Subject: Huntington Beach Seawater Desalination Facility Groundwater Model
 Evaluation

Huntington Beach Seawater Desalination Facility Groundwater Model Evaluation

HydroFocus, Inc., Davis, CA
August 19, 2016

Figure 1. Effects of changes to the Talbert Aquifer hydraulic conductivity on inland flow (a), wetland flow (b), and mean Layer 8 water level decline (c).

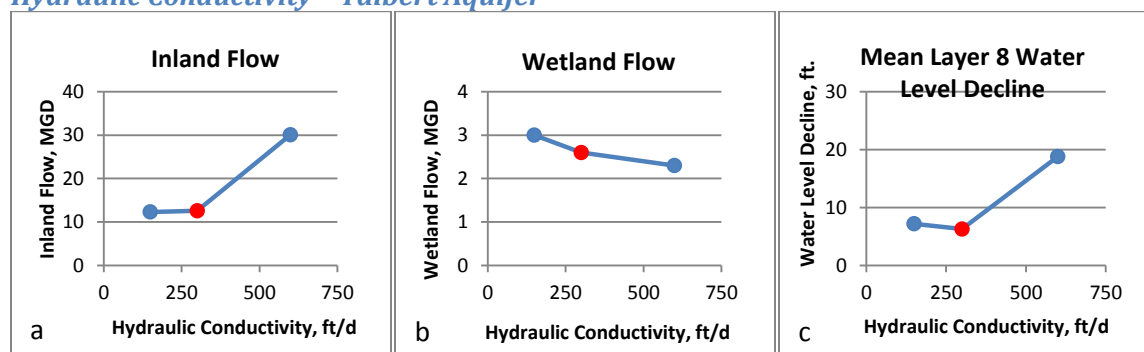
Model results are more sensitive to increases in the hydraulic conductivity of the Talbert Aquifer than to decreases. Specifically, a 100% increase in the horizontal and vertical hydraulic conductivity (these parameters were varied together) of the Talbert Aquifer resulted in significant increases in flow from the inland boundary (140%) (Figure 1a) and Layer 8 water level decline (200%)(Figure 1c). Decreasing the horizontal and vertical hydraulic conductivity by 50% had a minimal effect on inland flow and water level decline (-2% and 14%, respectively)(Figures 1a and 1c). Increasing and decreasing the hydraulic conductivity of the Talbert aquifer resulted in minimal changes to the wetland flow (-12 to 15%) (Figure 1b).

Figure 2. Effects of changes to the hydraulic conductivity in the layers overlying the Talbert Aquifer on inland flow (a), wetland flow (b), and mean Layer 8 water level decline (c).

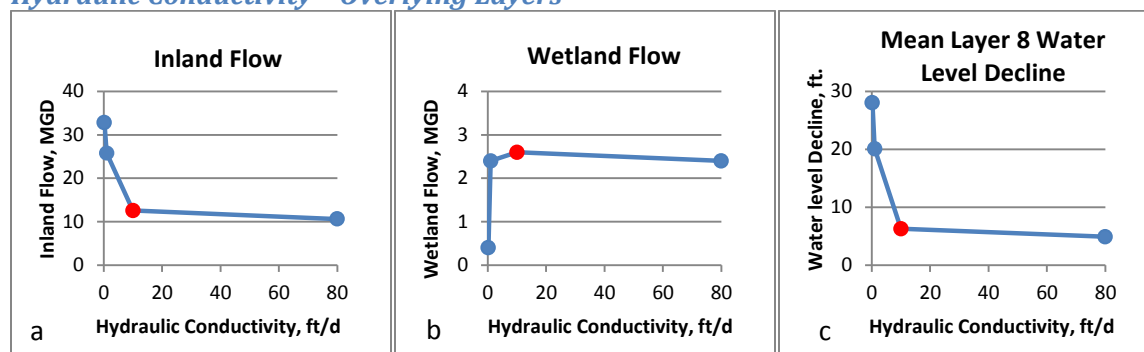
The horizontal and vertical hydraulic conductivity in the model layers overlying the Talbert Aquifer was decreased (Layer 2-4) and increased (Layers 3-4). Layer 8 water level decline was most sensitive to decreasing the hydraulic conductivity of the overlying layers (220% to 340% change in water level decline) (Figure 2c). Inland flow was also most sensitive to decreasing the hydraulic conductivity. Inland flow changed as much as 160% (Figure 2a) and wetland flow changed as much as -85% (Figure 2b) due to decreasing the hydraulic conductivity from 10 ft/d to 0.2 ft/d. Changes to inland and wetland flow and Layer 8 water level decline were relatively insensitive to increasing hydraulic conductivity.

Figure 3. Effects of changes to the hydraulic conductivity in the layers underlying the Talbert Aquifer on inland flow (a), wetland flow (b), and mean Layer 8 water level decline (c).

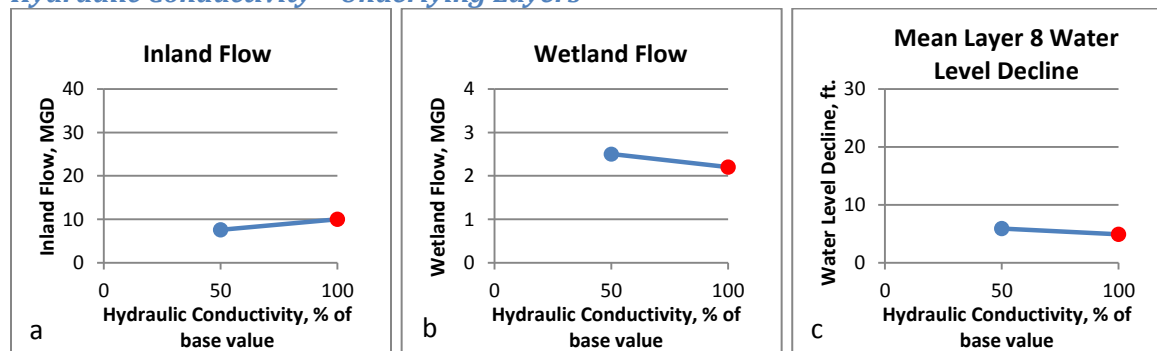
The results shown in Figures 3 through 6 were for model runs in which the specified pumping rate of was 100 MGD. The horizontal and vertical hydraulic conductivity in the underlying layers (Layers 9-10) was decreased 50%. A 50% decrease in the hydraulic conductivity of the underlying layers resulted in relatively small changes of -24%, 14%, and 20% change in inland flow, wetland flow, and Layer 8 water level decline, respectively (Figures 3a, 3b, and 3c).

Figure 4. Effects of changes to the slant well pumping rates on inland flow (a), wetland flow (b), and mean Layer 8 water level decline (c).

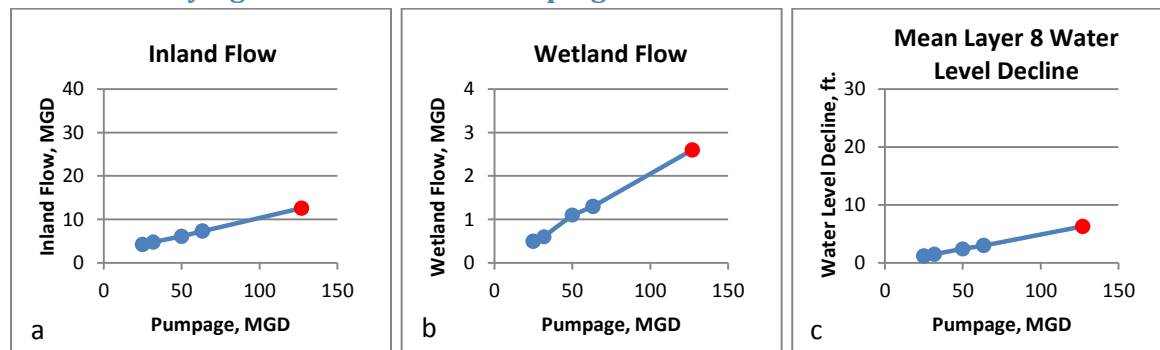
Inland and wetland flow and Layer 8 water level decline are linearly related to the slant well pumping rate. Decreases in the slant well pumping rate result in corresponding decreases in inland and wetland flow and water level decline. The relative impact of reduced pumping is greater on the wetland flow (Figure 4b) and Layer 8 water level decline (Figure 4c) (up to -81% change) than on inland flow (Figure 4a) (up to -67% change).

Figure 5. Effects of slant well screen length on inland flow (a), wetland flow (b), and mean Layer 8 water level decline (c).

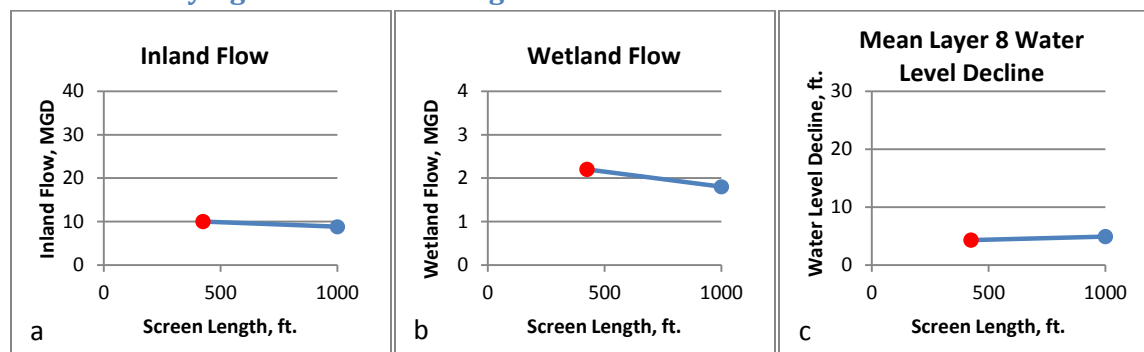
The slant well screen was lengthened and extended farther offshore than the 425-ft well screens used in the base run. These runs were made using a pumping rate of 100 MGD. A 135% increase in the well screen length resulted in relatively small changes of -12%, -18%, and 14% change in inland flow, wetland flow, and Layer 8 water level decline, respectively (Figures 5a, 5b, and 5c).

Figure 6. Effects of barrier head elevation on inland flow (a), wetland flow (b), and mean Layer 8 water level decline (c).

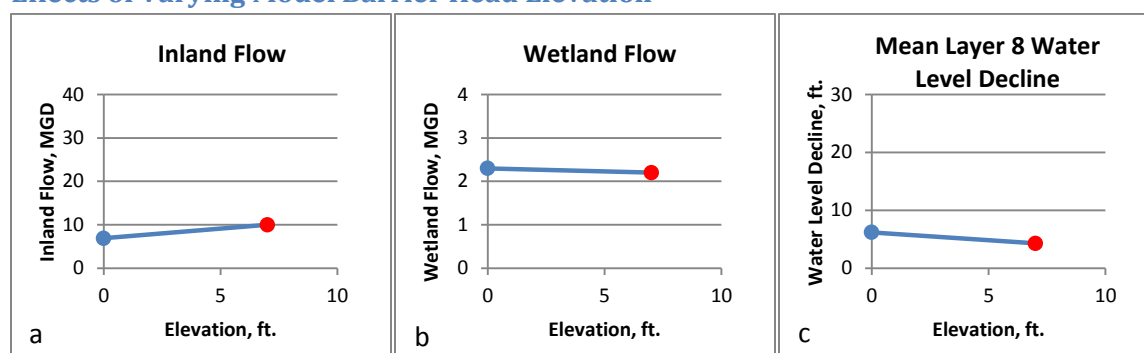
The water levels specified in the constant head cells representing the seawater intrusion barrier were reduced from the base value (about 7 ft. in Layers 2-8, 10 ft. in Layers 9-10) to 0 ft. in all layers. Because slant well pumping would create a sea water intrusion barrier, lower water levels at the Talbert Gap seawater intrusion barrier will likely result in an effective barrier¹². These runs were made using a pumping rate of 100 MGD. The change in the barrier water level resulted in a -31%, -5%, and 44% change in inland flow, wetland flow, and Layer 8 water level decline, respectively (Figures 6a, 6b, and 6c).

Figure 7. Effects of slant well location on inland flow (a), wetland flow (b), and mean Layer 8 water level decline (c).

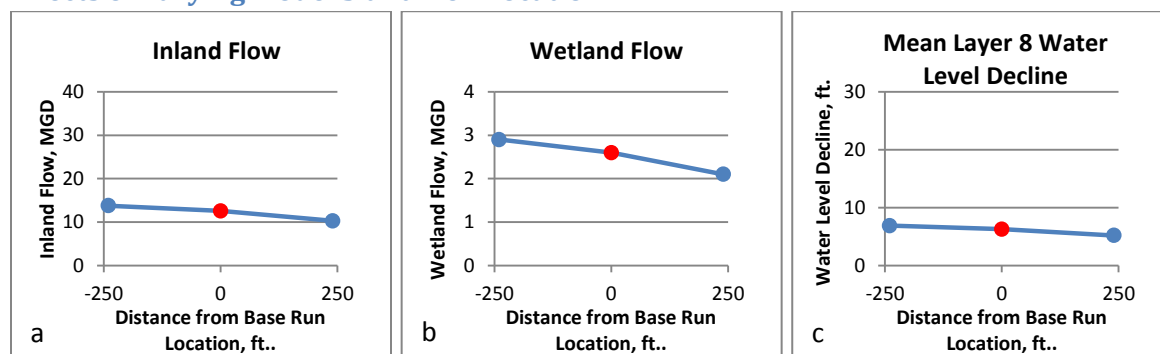
distance and the run with the well location farther seaward is shown as a positive distance from the base run location, respectively (Figures 7a, 7b, and 7c). Moving the wells farther inland resulted in relatively small changes of 10%, 12%, and 10% change in inland flow, wetland flow, and Layer 8 water level decline, respectively. Moving the wells farther seaward resulted in relatively small changes of -18%, -19%, and -17% change in inland flow, wetland flow, and Layer 8 water level decline, respectively.

Figure 8. Groundwater flow paths to the slant wells.

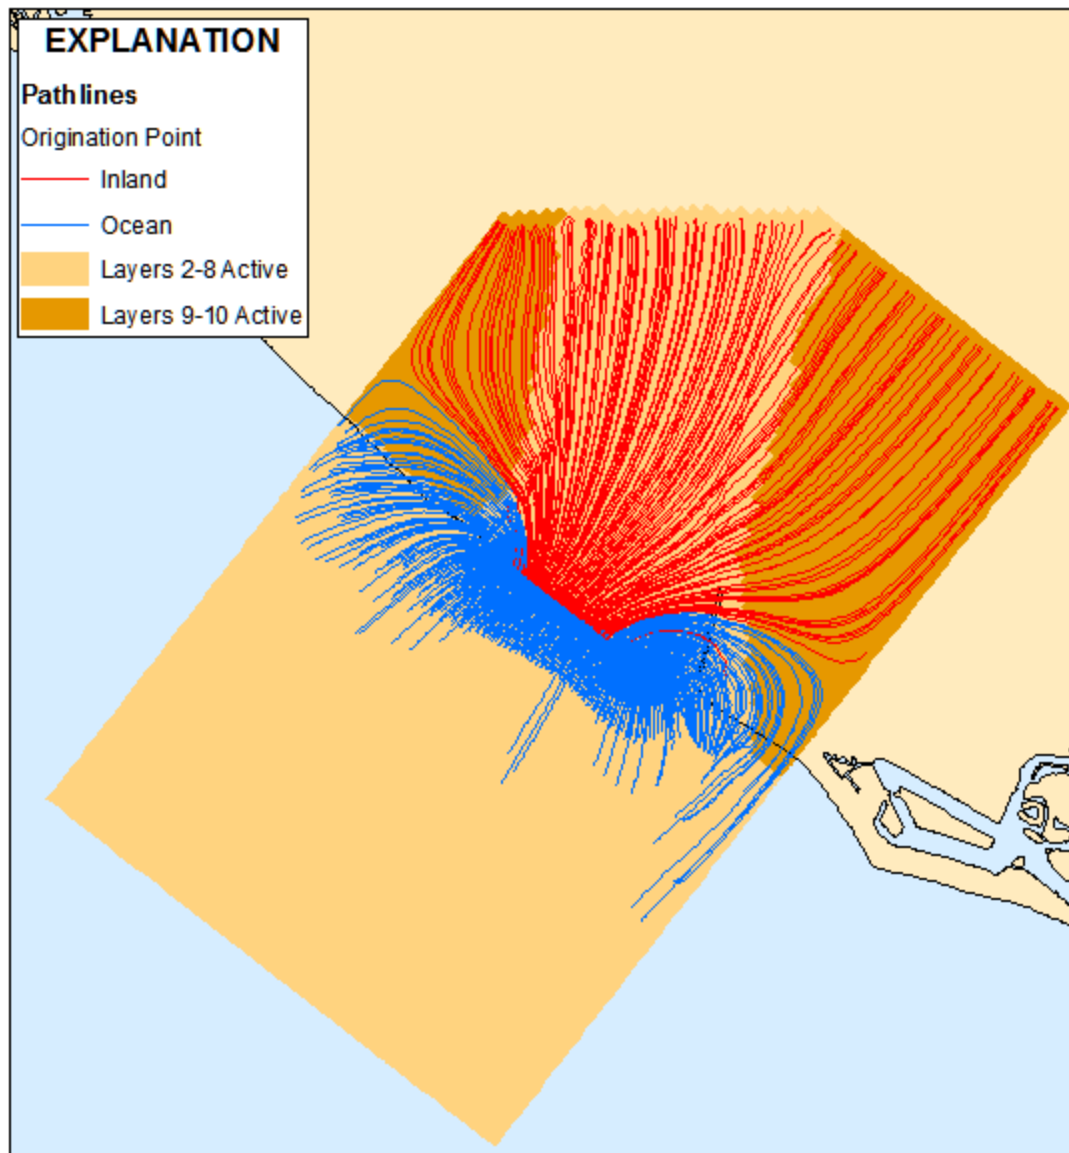
Figure 8 shows the groundwater flow paths to the slant wells (Geosyntec model 6, 127 MGD pumpage rate). Eighty-seven percent of the pathlines originate in the ocean and 13 percent originate inland. This is similar to the percentage of flow to the slant wells from the ocean and from inland (wetlands and intrusion barrier). Average travel time for the pathlines that originate near the intrusion barrier is about 20 years. Using a pumping rate of 63.5 MGD (one-half the base rate) increased the Talbert Aquifer travel time from the barrier to the slant wells to about 37 years. Using the base pumping rate of 127 MGD and setting the barrier constant heads to 0.0 ft. results in an average travel time in the Talbert Aquifer of 24 years.

Many of the pathlines in Figure 8 extend from the slant wells to the northwest and southeast toward the lateral boundaries of the model and turn sharply toward the ocean or the constant head cells representing the barrier. This sharp turn in some pathlines suggest that the simulated groundwater flow paths are being affected by the lateral extent of the model, primarily in Layers 9 and 10.

Our analysis indicates that the large majority of the water flowing to the slant wells will come from the ocean. Figure 8 indicates that operation of the slant wells will affect the extent of seawater intrusion in the Talbert Aquifer. The OCWD monitors groundwater levels and quality in the Talbert Gap to assess the effectiveness of the seawater intrusion barrier.¹⁷ The OCWD monitoring well OCWD-M26 is

Figure 9. Relation of pumpage rate and inland flow.

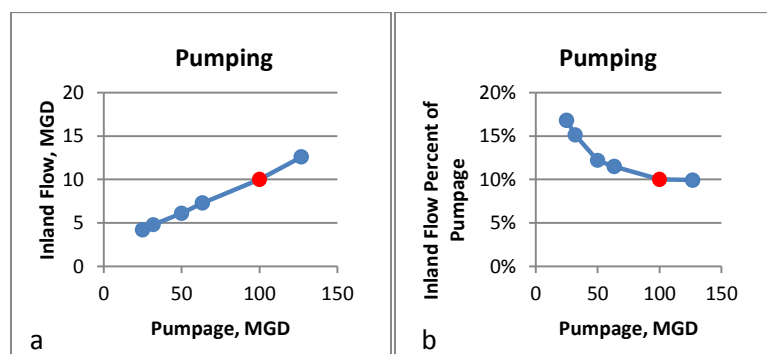
The model runs using varying pumping rates may potentially be used to select the optimum pumpage rate to minimize the proportion of pumpage originating as flow from the inland seawater intrusion barrier. The volume of water originating as flow from the inland barrier is directly proportional to the pumping rate (Figure 9a). However, the percent of the pumpage volume that originates as flow from the inland barrier is not directly proportional (Figure 9b). As the pumpage increases, the percentage of the pumpage that originates as inland flow from the barrier decreases. At pumping rates of 63.5 MGD and above, the percentage of pumpage that originates as inland flow does not change significantly.

The sensitivity results show that the specified aquifer properties and other model inputs affect the calculated percent of pumpage that originates as inland flow from the barrier. For example, using a pumping rate of 127 MGD, doubling the hydraulic conductivity of the Talbert Aquifer increased the percent of pumpage that originates as inland flow from 10% to 24%. Likewise, decreasing the hydraulic conductivity of the material overlying the Talbert aquifer up to 98% increased the percent of pumpage that originates as inland flow from 10% to 26%. Using a pumping rate of 100 MGD, increasing the hydraulic conductivity of the material overlying the Talbert Aquifer or decreasing the hydraulic conductivity of the material underlying the Talbert Aquifer decreased the percent of pumpage that originates as inland flow from 10% to 9% and 8%, respectively. Combining several changes to model input (increasing slant well length, increasing the hydraulic conductivity of the overlying material, decreasing the hydraulic conductivity of the underlying material, and lowering the water level maintained at the barrier) decreased the percent of pumpage that originates as inland flow from 10% to 4%.
